**Re: Huntington Beach Energy Project (12-AFC-02)  
Applicant's Correspondence Related to Air Quality (January and February 2013)**

**APPLICATION FOR CERTIFICATION FOR THE  
HUNTINGTON BEACH ENERGY PROJECT**

**Docket No. 12-AFC-02  
PROOF OF SERVICE  
(Revised 02/19/2013)**

# Figure DR25-1: HBEP Total Nitrogen Deposition on Surrounding Habitats

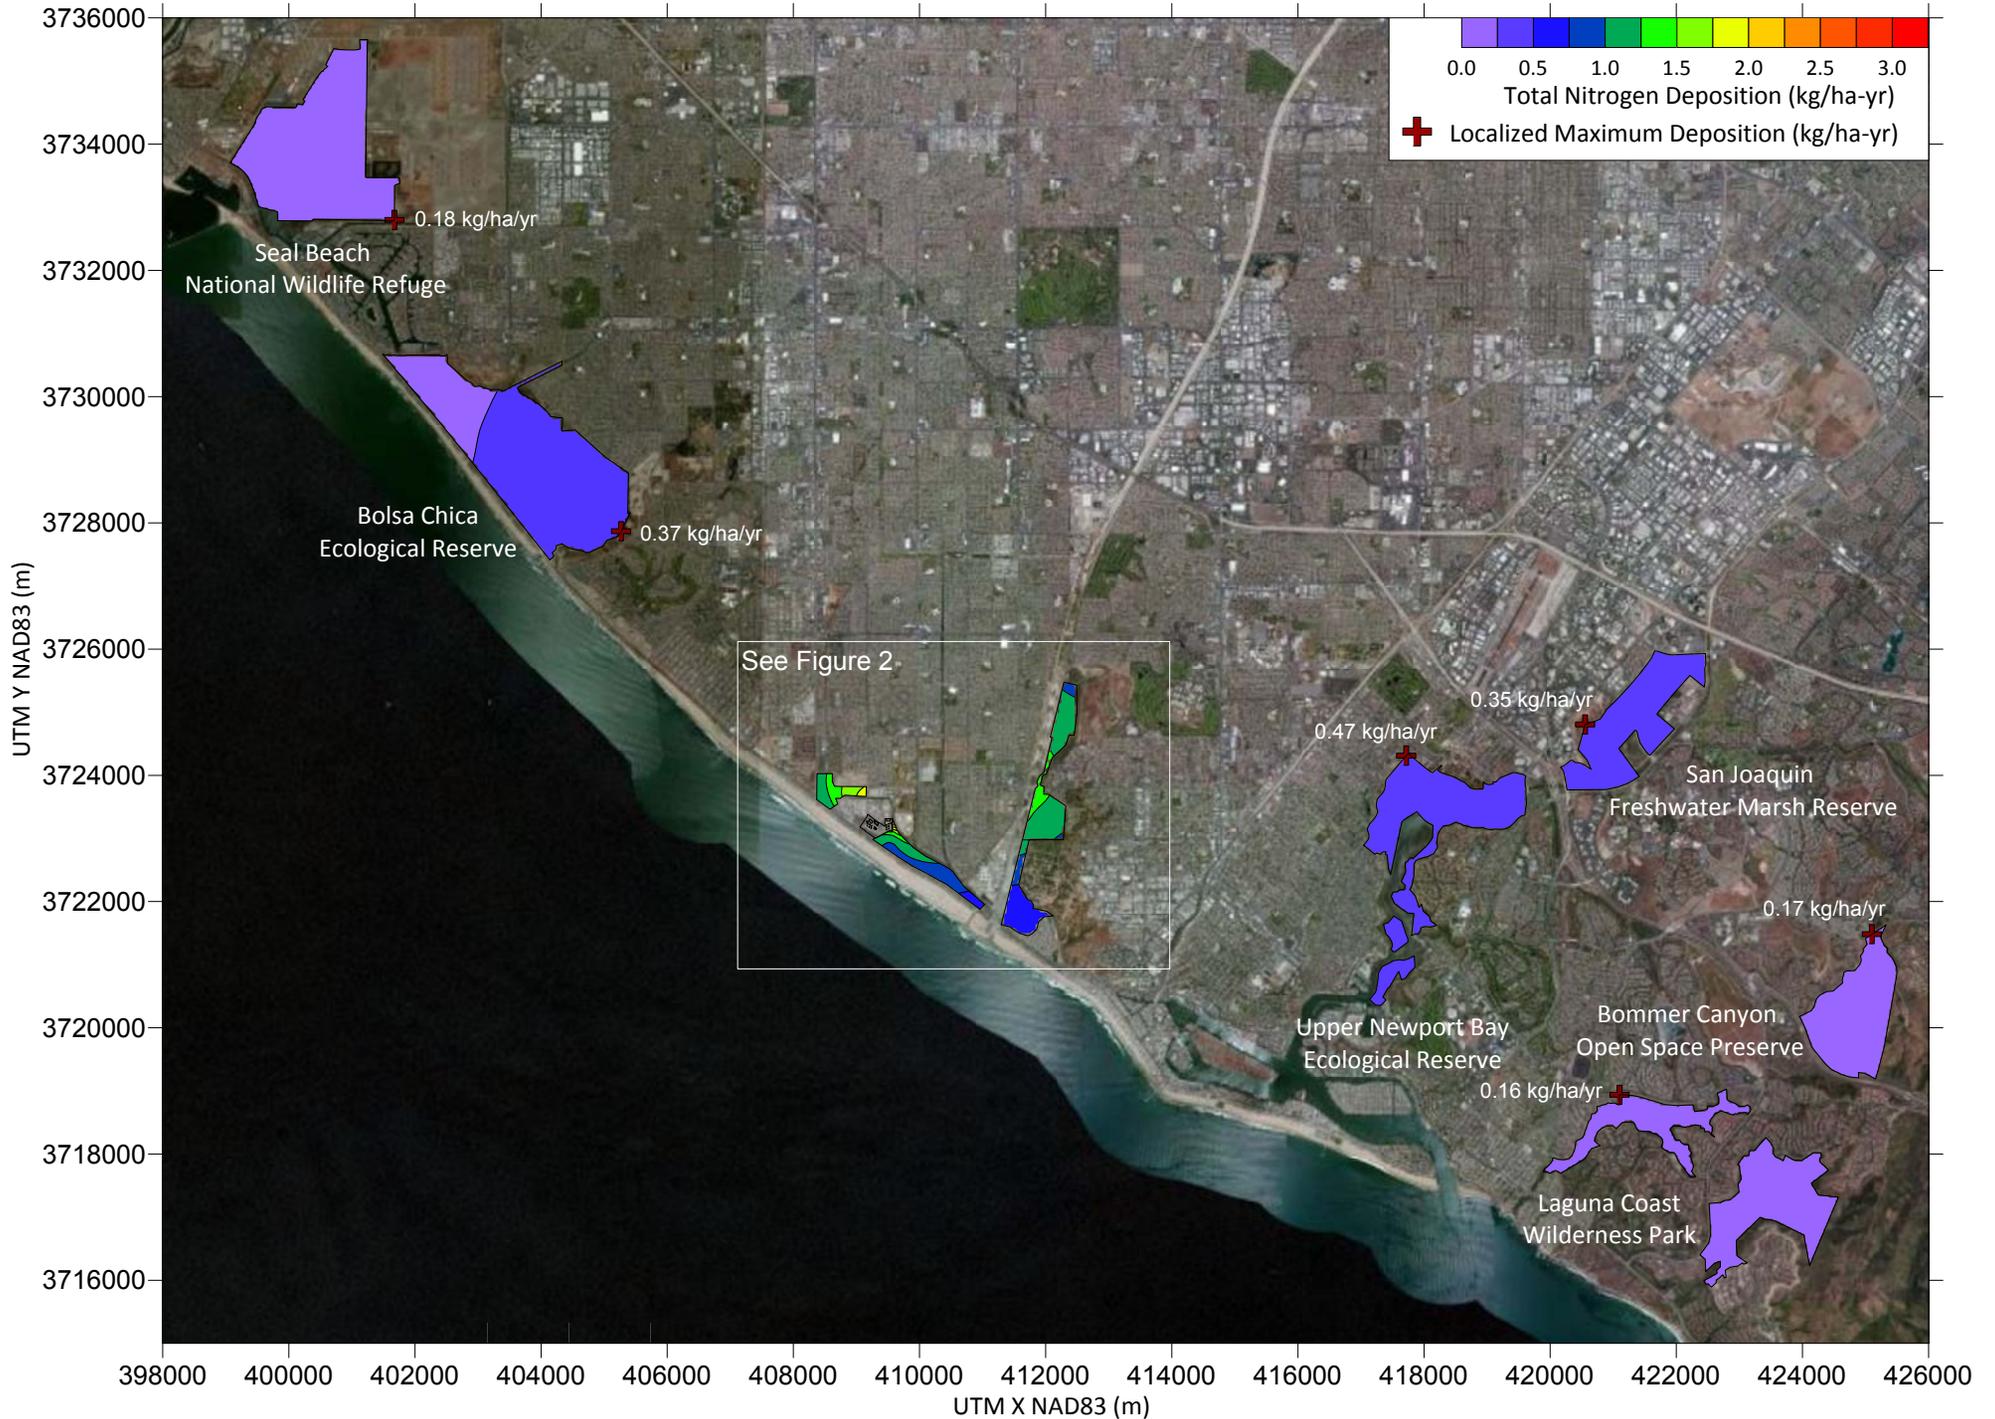
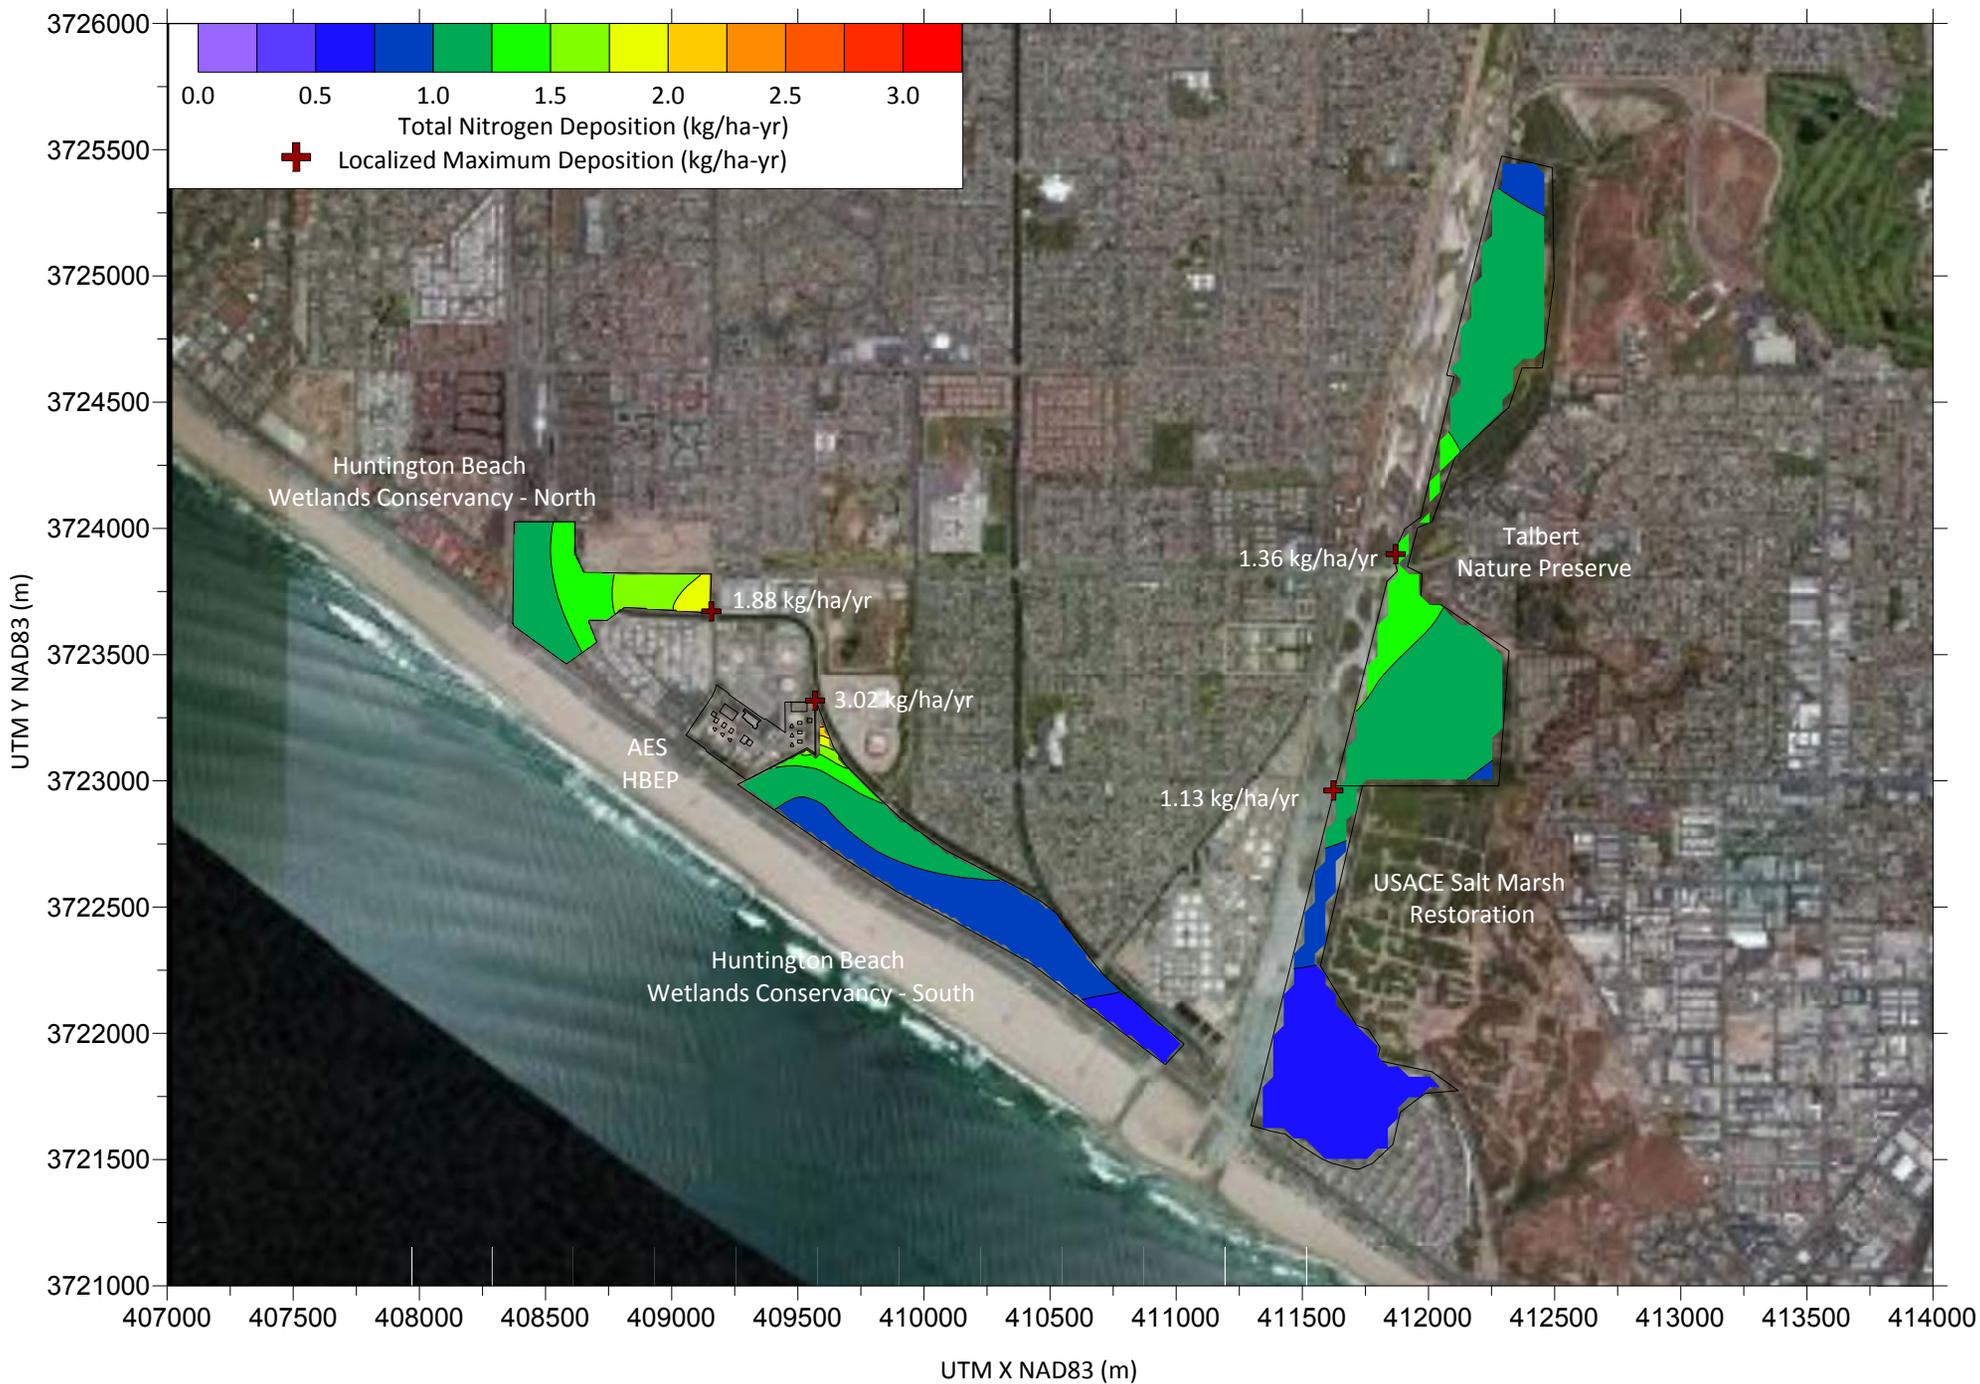
25. Please provide an isopleth graphic over USGS 7.5-minute maps (or equally detailed map) of the direct nitrogen deposition rates caused by the project. This will be a graphical depiction of the projects’ nitrogen deposition.

**Response:** The predicted nitrogen deposition flux isopleths are included in Figures DR25-1 and DR25-2.

# Figure DR26-1: HBEP Cumulative Nitrogen Deposition on Surrounding Habitats

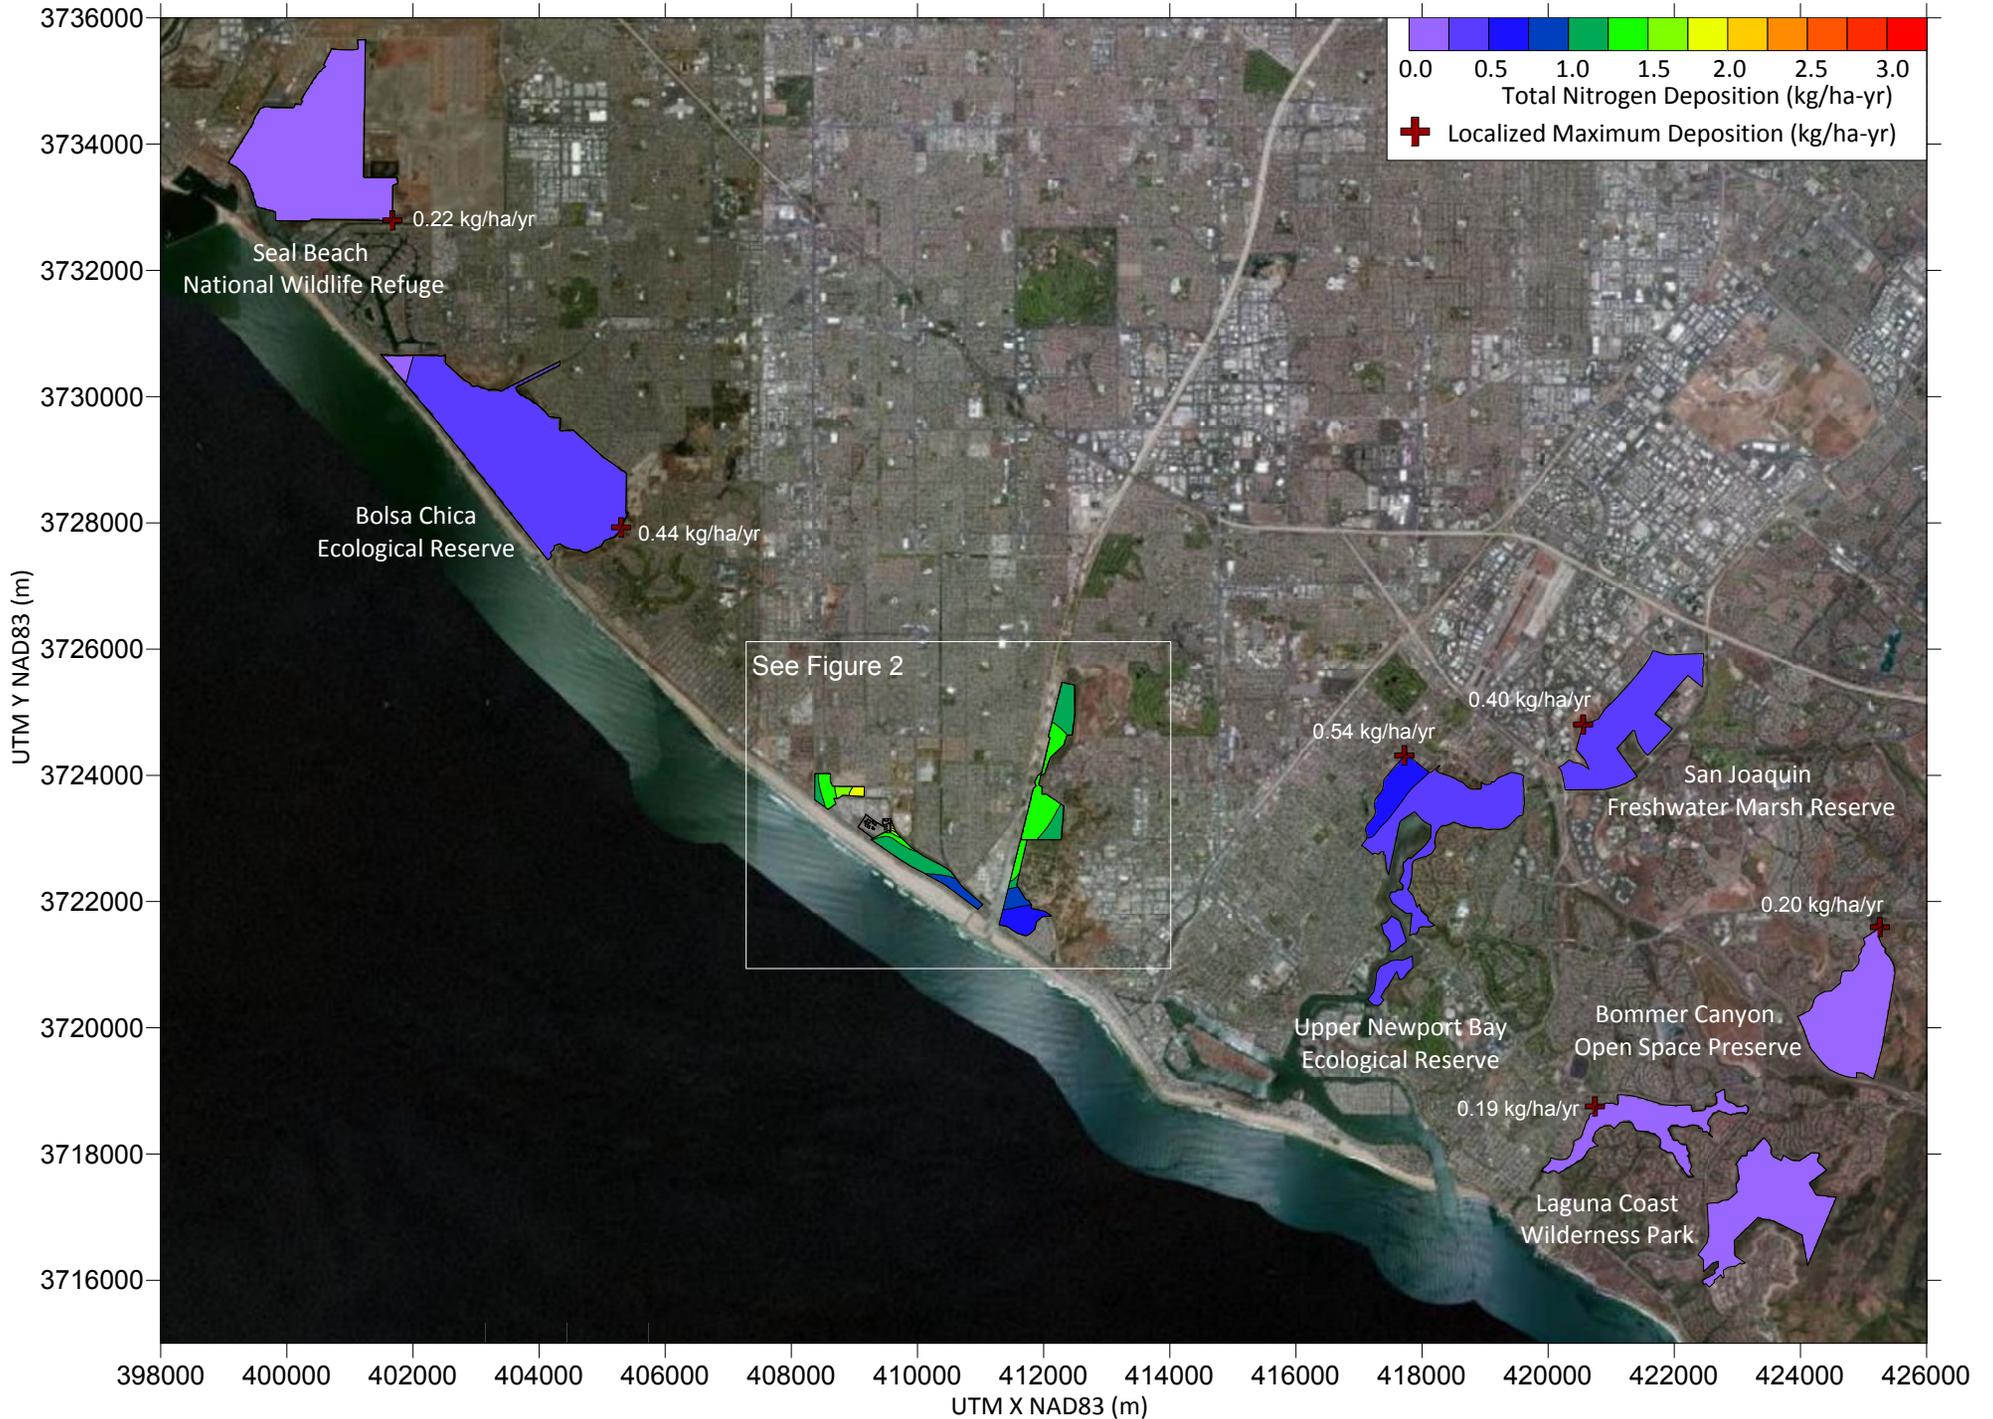
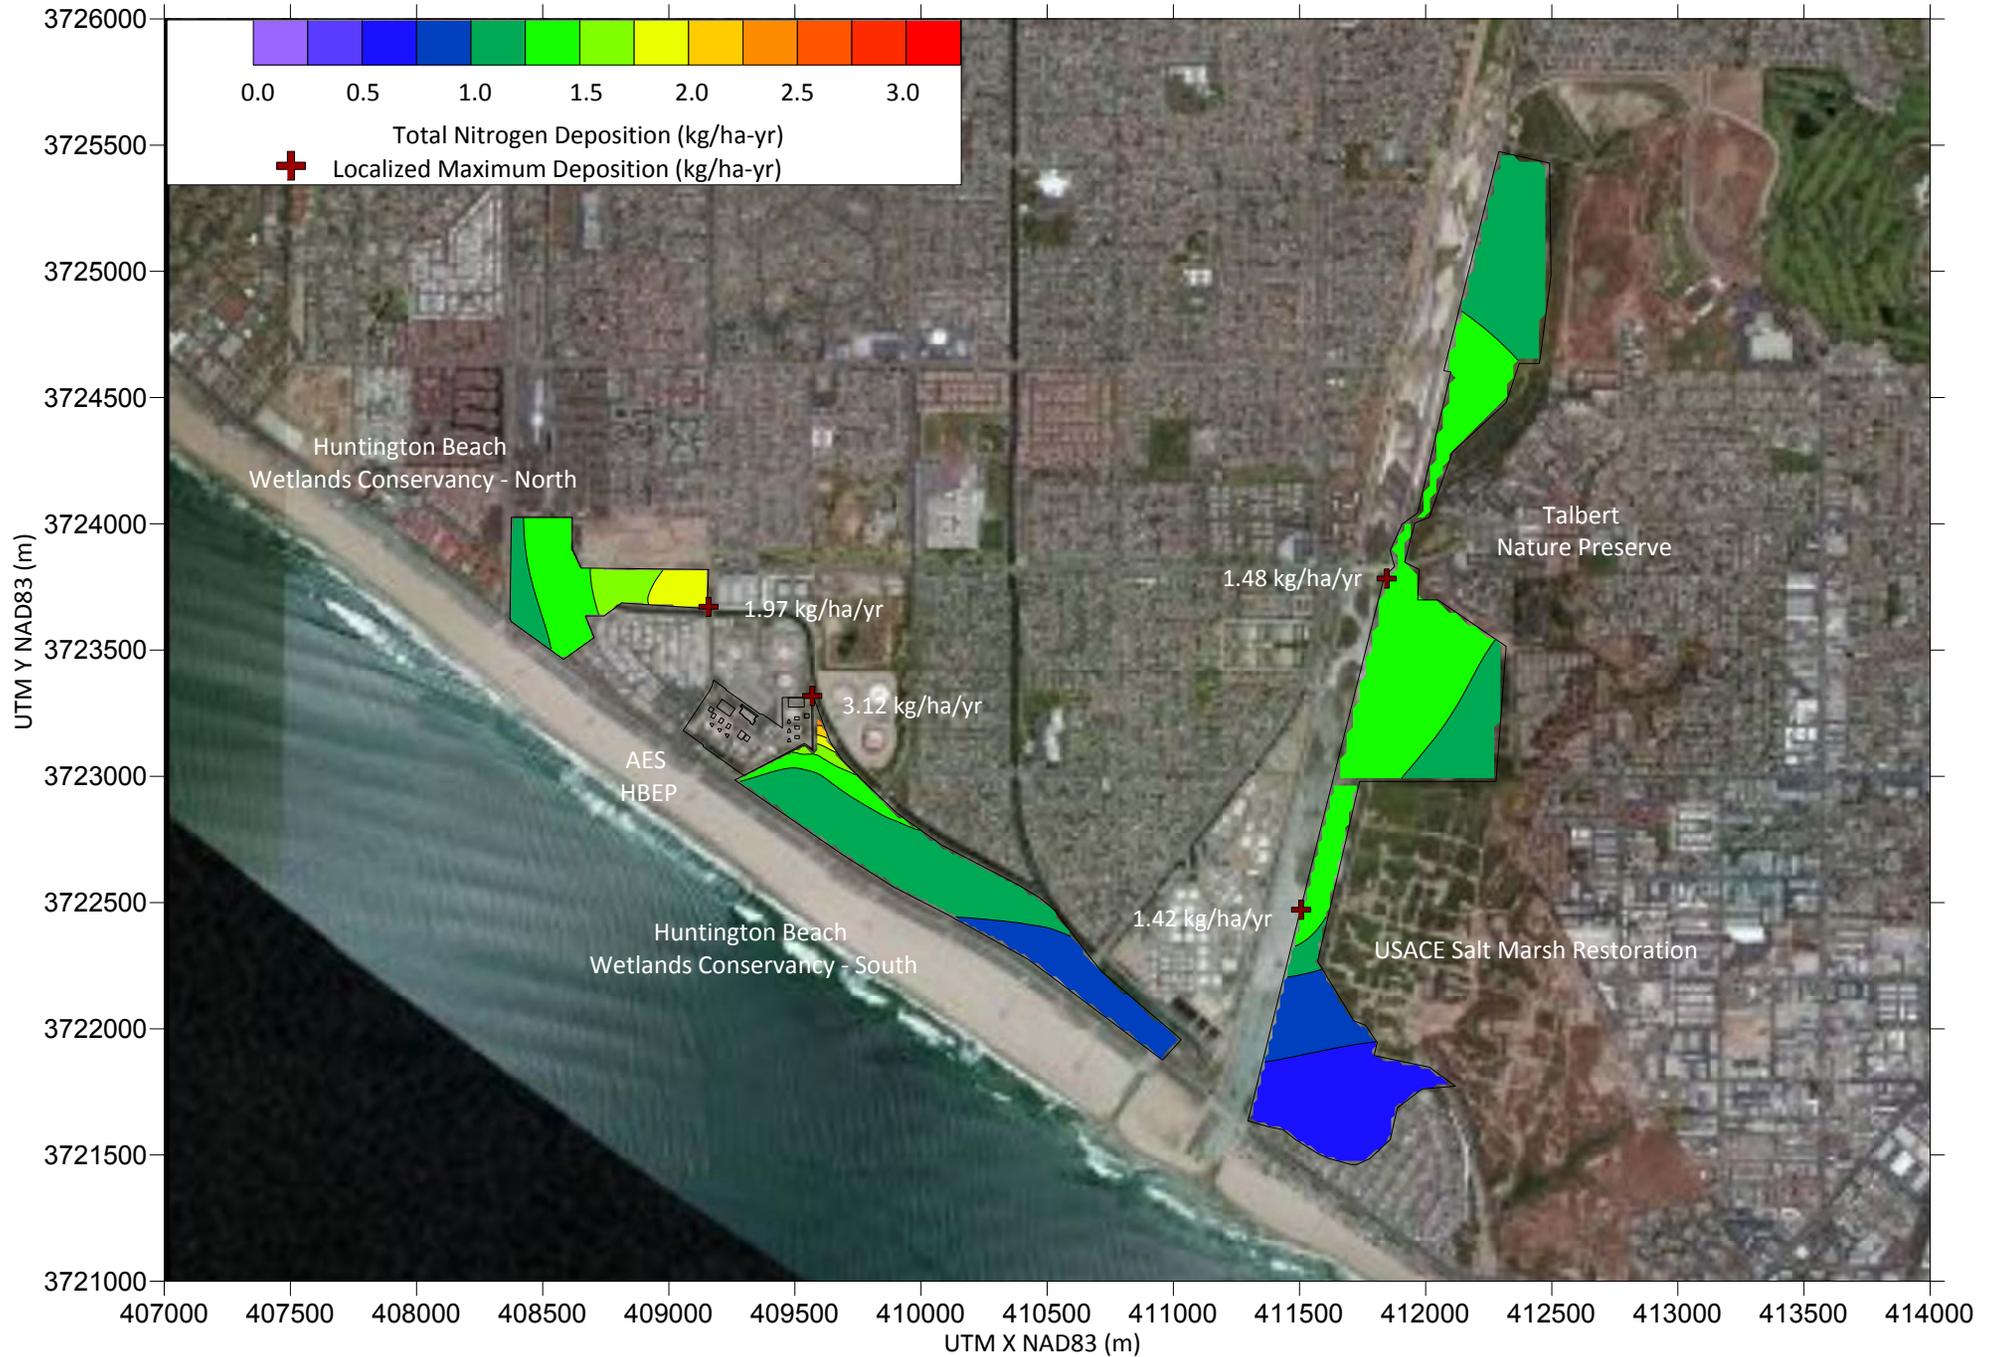
26. Please provide a comprehensive cumulative impact analysis for the direct nitrogen deposition in kg/ha/yr caused by HBEP. Provide an isopleths graphic over USGS 7.5-minute maps of the direct nitrogen deposition values in the cumulative analysis and specify the cumulative nitrogen deposition rate in kg/ha/yr at any affected special status habitat, vegetation type, or critical habitat. The geographical extent of the cumulative nitrogen deposition mapping should be directed by the results, i.e. extend geographically to where the deposition is considered below any stated threshold of significance.

**Response:** The sources included in the cumulative nitrogen deposition analysis are the same NO<sub>x</sub> emitting sources identified in the response to Data Request 11. Similar to the HBEP sources, emissions of depositional nitrogen were conservatively calculated as a complete conversion of in-stack NO<sub>x</sub> from each source. Emissions of ammonia from the cumulative sources were considered negligible and therefore were not considered as a source of depositional nitrogen. Emissions from each source are shown in Table DR26-1.
